TAUPŌ DISTRICT PLAN

In the matter of: **Proposed Plan Change 36**

Whareroa North – Rezone land from rural environment to residential environment

JOINT WITNESS STATEMENT (LANDSCAPE)

Ability to accommodate Change

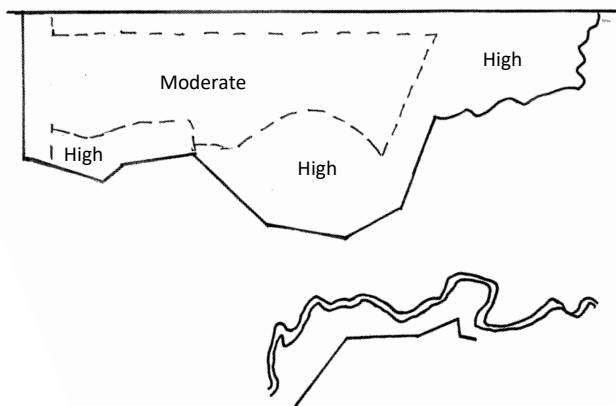
It was **agreed** that these would be further developed within the rebuttal evidence of Ms Monzingo. There was also **agreement** that the draft working version ('Site specific values' draft and dated 27 May, 2020 – **Attachment B**) provided agreed principles for evaluating those values.

Ms Ryder identified that these should be elaborated on for the OLA in terms of the amended *Pigeon Bay* criteria and consistent with the factors listed in Table 12-2¹-, Part B, 12B of the Waikato Regional Policy Statement.

It was **agreed** that subject to the analysis outlined in (2) above in terms of analysis of effects on the OLA that these matters have been identified.

Areas of the Land with high ability to accommodate change without adversely affecting the landscape values of the Land and the surrounding landscape:

- along the north and northwest boundary, adjacent to the area of regenerating scrub, which has low sensitivity to changes on the Land as a result of the existing vegetation that visually screens views of the Land and the low human use of this area;

- within the area of low scrub of bracken and shrubs as a result of the visual screening provided by the adjacent existing indigenous vegetation with heights of 6 m to 16 m and the proposed protected vegetation within this area. The adjacent area of the plateau (between the Land and OLA 60), to the east of the Land has a moderate sensitivity to change on the Land as a result of the existing indigenous vegetation within the area that limits views of the Land and the low human use of this area; and

- along the southeast and southern boundary of the Land and the lower lying area of the bowl as a result of the visual screening provided by the adjacent existing indigenous vegetation with heights of 6 m to 16 m. The adjacent area of the plateau to the south of the Land has a moderate sensitivity to change on the Land as a result of the existing indigenous vegetation within the area that limits views of the Land and the low human use of this area.

Areas of the Land with moderate ability to accommodate change without adversely affecting the landscape values of the Land and the surrounding landscape:

- areas not located adjacent to areas of existing indigenous vegetation and thus have the potential to be more visible from the surrounding landscape

- adjacent to the rural land to the west of the Land, which has moderate sensitivity to changes on the Land as a result of the of the manuka plantation that will in time limit views of the Land and the moderate human use of the rural land;
- the area of the Land above proposed indigenous planting within the bowl to avoid buildings in this area appearing visually prominent; and
- the area of the Land below the proposed indigenous planting within the bowl, where the upper slope of the bowl is less pronounced, to avoid buildings in this area appearing visually prominent.

Maximum Building Heights

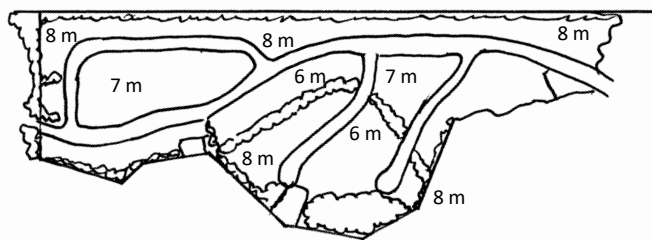
Ms Ryder and Ms Monzingo **agreed in principle** the design outcomes, as based on the draft Building Heights Plan and Maximum Building Heights analysis provided by Ms Monzingo for the discussion (**Attachment C** – Maximum Building Heights Draft, Additional information regarding planting as dated 27 May 2020) would provide certainty as to outcomes.

It was **agreed** that Ms Monzingo will further elaborate on that discussion in her rebuttal and seek provide greater precision in plan change mechanisms associated with further mitigation necessary is appropriate in terms of responding to sensitivities and values within the site.

Areas of the Land with an 8 metre maximum height of buildings:

- along the north and northwest boundary, adjacent to the area of regenerating scrub, which has low sensitivity to changes on the Land as a result of the existing vegetation that visually screens views of the Land and the low human use of this area;

- within the area of low scrub of bracken and shrubs as a result of the visual screening provided by the adjacent existing indigenous vegetation with heights of 6 m to 16 m and the proposed protected vegetation within this area. The adjacent area of the plateau (between the Land and OLA 60), to the east of the Land has a moderate sensitivity to change on the Land as a result of the existing indigenous vegetation within the area that limits views of the Land and the low human use of this area; and

- along the southeast and southern boundary of the Land and the lower lying area of the bowl as a result of the visual screening provided by the adjacent existing indigenous vegetation with heights of 6 m to 16 m. The adjacent area of the plateau to the south of the Land has a moderate sensitivity to change on the Land as a result of the existing indigenous vegetation within the area that limits views of the Land and the low human use of this area.

Areas of the Land with a 7 metre maximum height of buildings;

- areas of the Land that are not located adjacent to areas of existing indigenous vegetation and thus have the potential to be more visible from the surrounding landscape

Areas of the Land with a 6 metre maximum height of buildings:

- adjacent to the rural land to the west of the Land, which has moderate sensitivity to changes on the Land as a result of the of the manuka plantation that will in time limit views of the Land and the moderate human use of the rural land;
- the area of the Land above proposed indigenous planting within the bowl to avoid buildings in this area appearing visually prominent; and
- the area of the Land below the proposed indigenous planting within the bowl, where the upper slope of the bowl is less pronounced, to avoid buildings in this area appearing visually prominent.
